ANN ARBOR HOUSING BOARD OF APPEALS

STAFF REPORT

Housing Board of Appeals Request HBA22-2001 at 227 Orchard Hills Dr, ANN ARBOR, MI 48104.

Subject: 227 Orchard Hills Drive / Appeal (CR09-0149)

This is the FLW Palmer House,
with eight 4" risers and 18" treads.

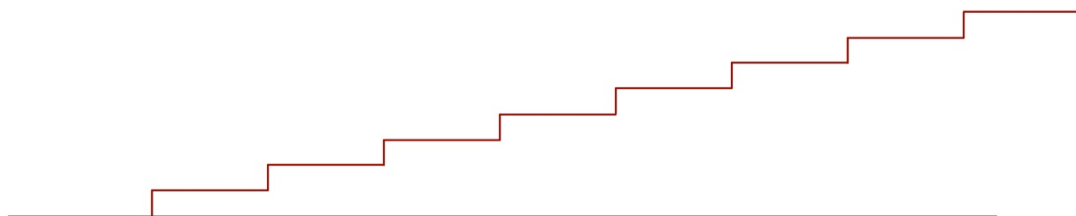
Front Entrance: The front entrance of the Palmer House has a lower series of eight 4" risers (half the height of a normal step) with 18" treads (twice the depth of a normal step), a landing, and an upper series of four 4" risers (half the height of a normal step) with 18" treads (twice the depth of a normal step). The lower series rises roughly 30" over a horizontal distance of 10 feet, while a normal staircase that rises the same amount would use only 2 feet.

This is a normal staircase and the FLW Palmer House, rising the same height, but over drastically different distances.

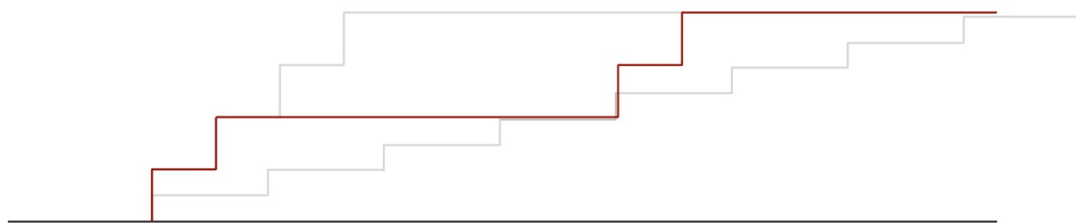
2. Significantly Safer than a Normal Staircase. The Rental Housing Ordinance of Ann Arbor goes to great lengths to specify the maximum rise and minimum tread of a staircase because these dimensions are critical to the safety of a staircase. Tall risers increase the chance that a pedestrian trips on a stair, and shallow treads reduce the chance that a pedestrian regains their balance. As detailed above, the 4” risers are exactly half the height of a normal step, which makes them safer because they reduce the chance that a pedestrian trips on the riser. And the 18” treads are exactly twice the depth of a normal step, which makes them safer because they increase the chance that a pedestrian regains their balance. Together, the short risers and deep treads combine to make the front entrance significantly safer than a normal staircase.

3. Unfair Burden. The lower series of the front entrance at the Palmer House rises roughly 30” in height across 10 feet of horizontal distance. A normal staircase that rises roughly 30” in height would need only 2 feet of horizontal distance. This enormous difference in horizontal distance (10 feet vs. 2 feet) creates an unfair burden. Rental Housing Services would require

a handrail of approximately 3 feet for the normal staircase, but has asked us to install a handrail of approximately 12 feet for the front entrance at the Palmer House. In most scenarios, when something is safer, it would require less of a regulatory burden. In our scenario, however, Rental Housing Services is asking us to install a handrail that is more than 4x longer than the handrail of a normal staircase, despite the clear fact that the front entrance of the Palmer House is safer than a normal staircase. The 12-foot handrail, which Rental Housing Services requires to be continuous, will likely need at least 5 holes drilled into the bricks or 7 holes drilled into the concrete, while a normal staircase would need only 2 holes. As mentioned above, these holes are irreversible damage to a home preserved for the last 70 years without any modifications. For this reason, the requirement of a handrail is an unfair burden.

This is an alternative staircase, with four 8" risers, interrupted by a five foot landing. The landing, under the housing rules, eliminates the safety requirement for a handrail.

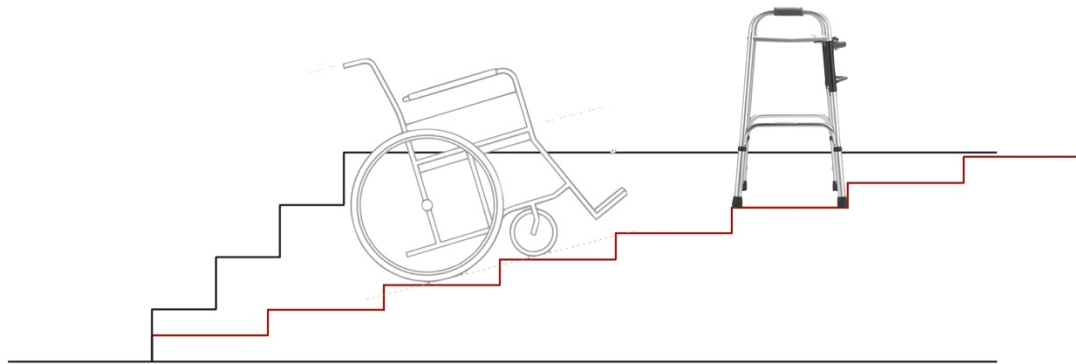
4. Safer than Equivalent Staircase that does not require Handrails. Because the eight 4" risers extend 10 feet to rise only 30", they can be easily reconfigured into an equivalent design with four 8" risers interrupted by a five foot landing, as shown below.

Because both sets only have two steps each and because they are "interrupted" by the landing, this equivalent design would not require a handrail under the Rental Housing Ordinance. They would not require a handrail, because Rental Housing Services deem this equivalent design to be safe. Returning to the previous argument, the front entrance of the Palmer House is safer than this equivalent design because the risers are shorter and the

treads are deeper. Because the front entrance of the Palmer House is safer than an equivalent staircase that does not require handrails, I believe that the front entrance of the Palmer House should not require a handrail.

This is the FLW Palmer House,
with eight 4" risers and 18" treads.

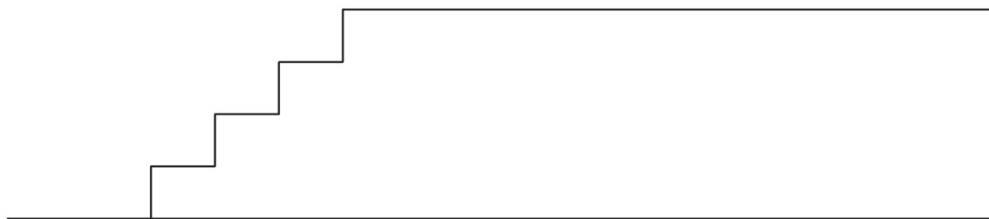
Front Entrance: The front entrance of the Palmer House, which was featured in a Chrysler advertisement and is arguably the most important view of the house, has a series of eight 4” risers (half the height of a normal step) with 18” treads (twice the depth of a normal step).

This is a normal staircase and the FLW Palmer House, rising the same height, but over drastically different distances.

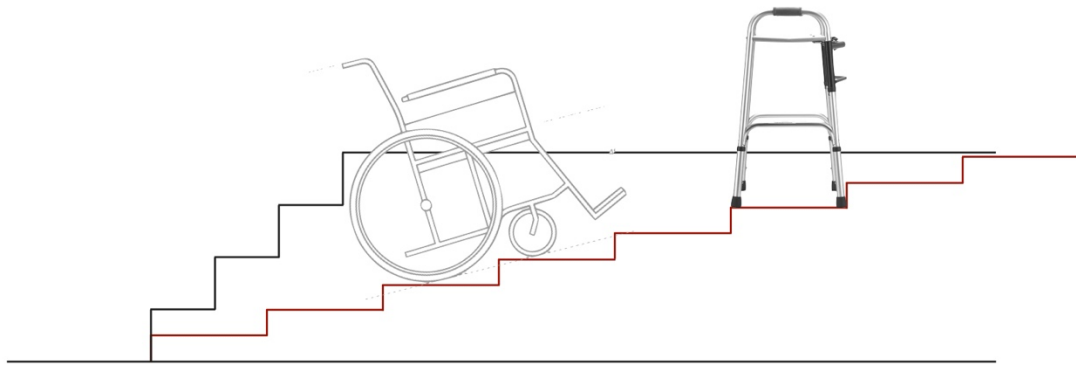
As mentioned above, the 4" risers are half the height of a normal step and the 18" treads are twice the depth of a normal step. Under previous versions of the Michigan housing code, these risers are so short and the treads so deep that they would not even be considered stairs. The challenge here is that the current Ann Arbor housing code simply does not contemplate risers this short and treads this deep. The front entrance rises roughly 30" over 10 feet, while a normal staircase would use just over 2 feet for the same rise.

In addition to being more safe, the 4" risers and the 18" treads make the Palmer House significantly more accessible to more people, as they accommodate both a wheelchair and a walker.

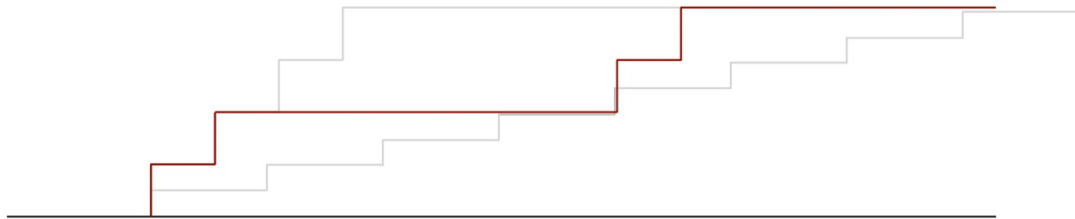
In addition to being safe, the front entrance of the Palmer House is significantly more accessible to more people, as the 4" risers are so short that they safely accommodate all four wheels of a wheelchair and the 18" treads are so deep that they safely accommodate all four legs of a walker. A guest in a wheelchair could *roll themselves* up the front entrance.

A normal staircase cannot safely accommodate either a wheelchair or a walker. Because it is at least as safe, if not safer, and certainly more accessible than a normal staircase, I ask for a variance on the requirement for a handrail.
